SUBJECT: Inland Empire Energy Center Project (01-AFC-17C)
Revised Staff Analysis of Proposed Modifications to Amend
Air Quality Conditions of Certification

INLAND EMPIRE ENERGY CENTER (01-AFC-17C)
Request to Amend Selected Air Quality Conditions of Certification
Tao Jiang, Ph.D., P.E.

**Air Quality Figure 1
IEEC Operating Record (02/09/2010 13:00-23:00)**

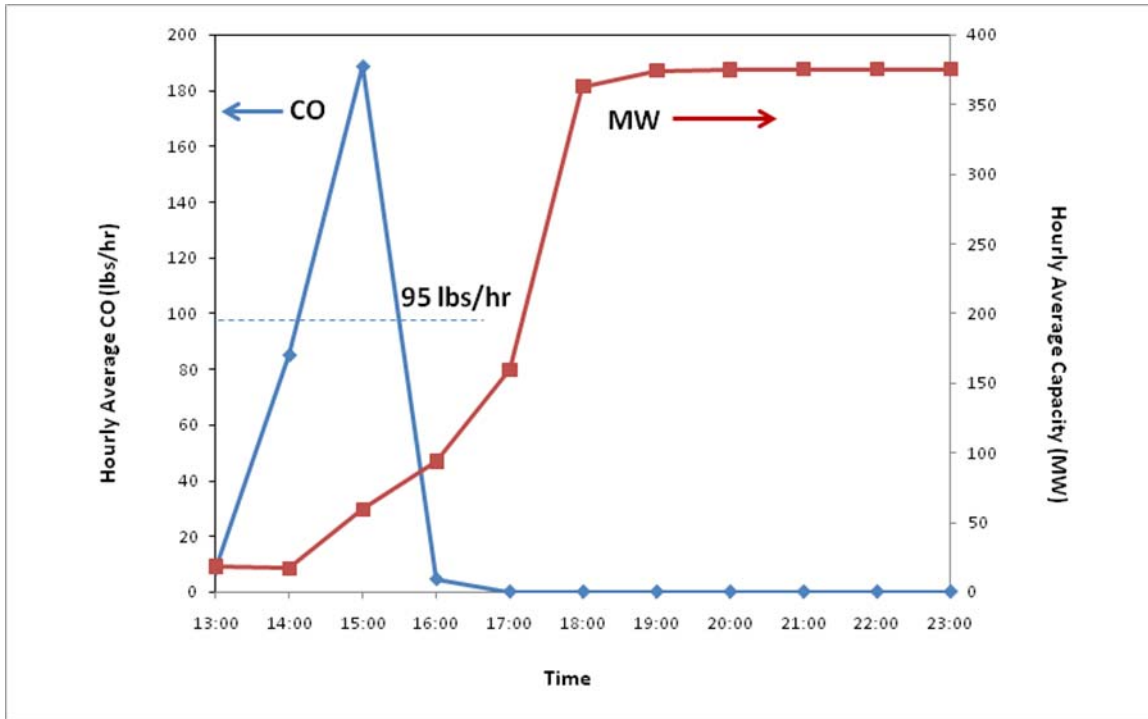
On February 19, 2009 and May 12, 2009, the applicant requested revisions to the permit to allow an increase in the CO emission limit from 95 lbs/hr to 800 lbs/hr and from 300 lbs/event to 2,000 lbs/event during startups/shutdowns of the two gas turbines. Since the gas turbines at this facility are the first General Electric S107H gas turbines operating in the United States, and the second and the third in the world, the original CO startup emission limits were based on very limited information available from the vendor. First quarter 2010 operating data (IEEC 2010) from the CO continuous emissions monitor for IEEC Unit 1 indicate that the CO emission rates during the turbine startup are higher than the original emission limit in the permit (95 lbs/hr). As an example, Air Quality Figure 1 plots the hourly average CO startup emissions and MW output measured versus time for a recent startup. For this startup event, the instantaneous CO emission peaked at 275.6 lbs/hour but when averaged over each clock hour, the maximum hourly CO emissions rate peaked at 189 lbs/hr.

Additionally, startup events with the six highest instantaneous carbon monoxide emission rates for the first quarter of 2010 are shown in **Air Quality Table 5**. These instantaneous values, expressed in pounds per hour, typically equate to lower actual average hourly values since the startup can start at any time during an hour and instantaneous rates do not appear to hold steady for the whole hour. The 800 lbs/hour CO limit is being requested as a ceiling value to accommodate rarer startup conditions (cold turbine start-up, cold ambient temperatures, or persistent equipment problems that extend the duration of a startup) with greater margin and are not typical of routine start-up emissions.

Notes: The data shown represent 1-hour average values. The maximum instantaneous CO emission (276 lbs/hr) is not shown in this figure.
